ADDENDUM NO. 01

DATE 06.19.2014

PROJECT VMDO Project No.1115, Renovation of Three Residence Halls
PC# 217-17565-001

NOTE: FLOOR PLAN IS FOR POCAHONTAS HALL, BOLLING HALL SIMILAR, DRAPER HALL SIMILAR EXCEPT OPPOSITE HAND.

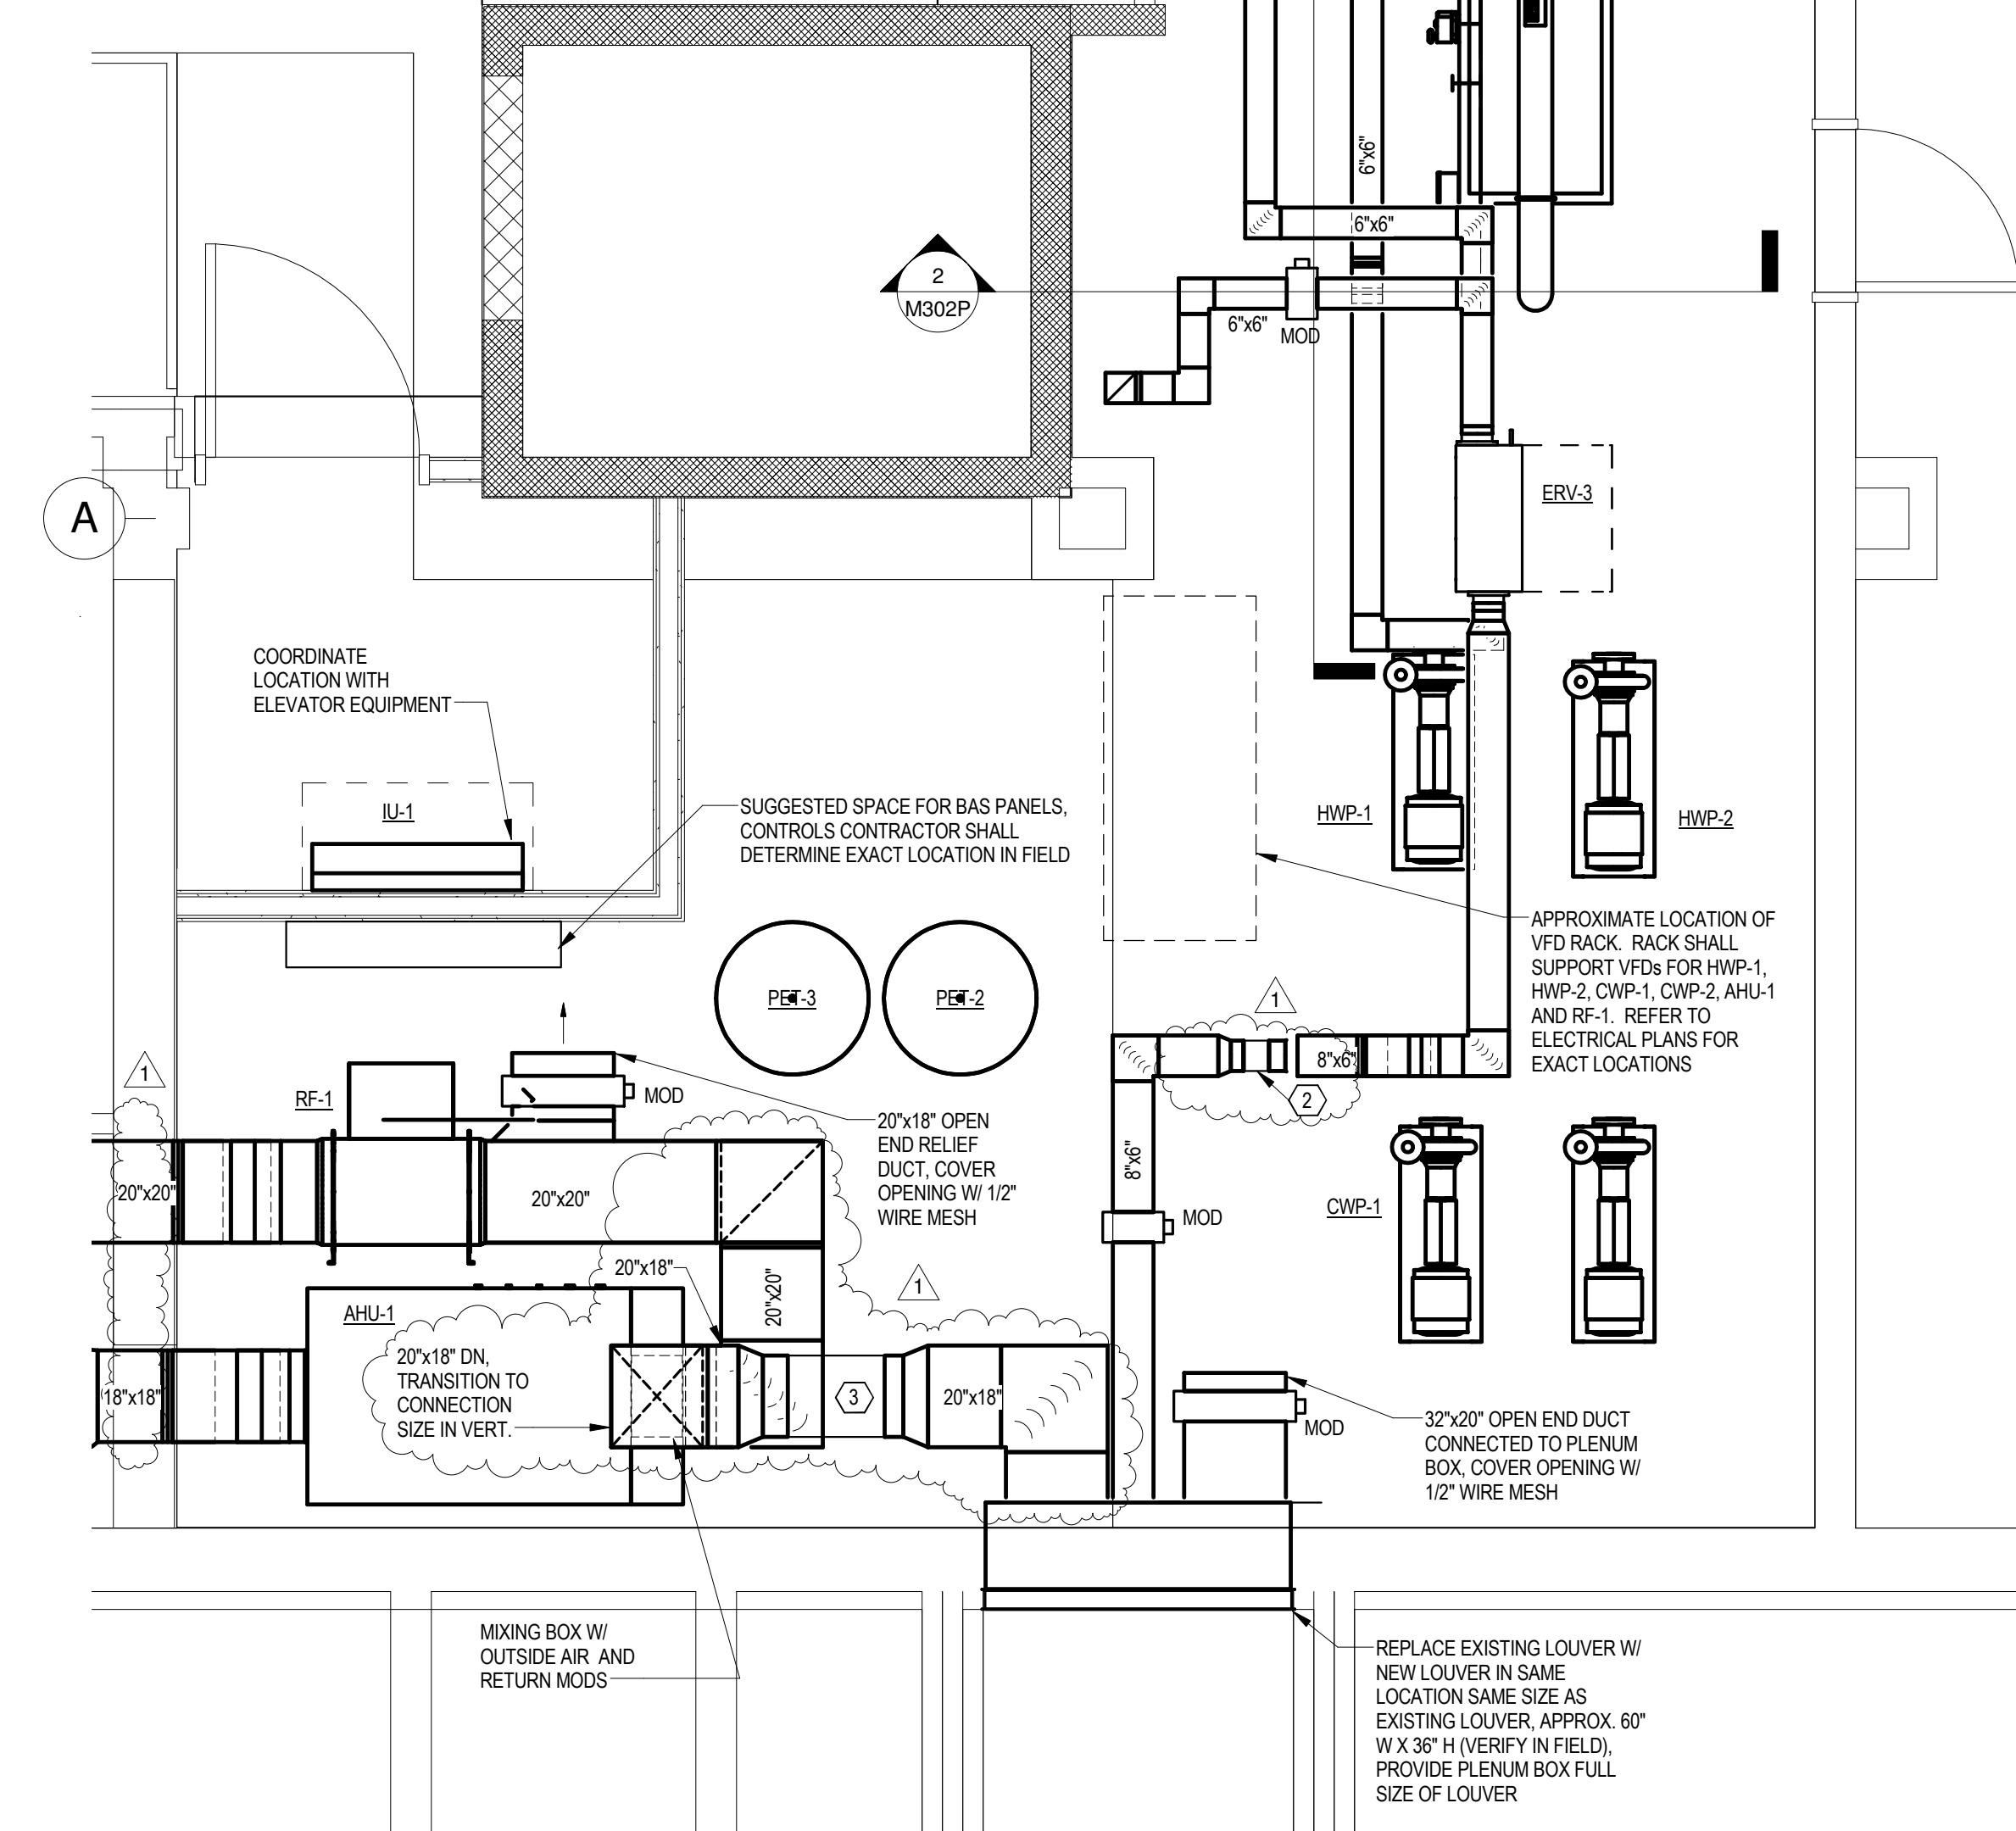
2.27 Remove fire dampers and add ductwork sizes to AHU-1 ductwork. Refer to attached revised drawing **M301P**.

2.28 Add airflow measuring station in AHU-1 outside air duct and modified duct routing. Refer to attached revised drawing M301P.

2.29 Add airflow measuring station in ERV-3 outside air ductwork. Refer to attached revised drawing **M301P**.

2.30 Modify ductwork routing in typical bathroom ductwork plans. Refer to attached revised drawing **M301P**.
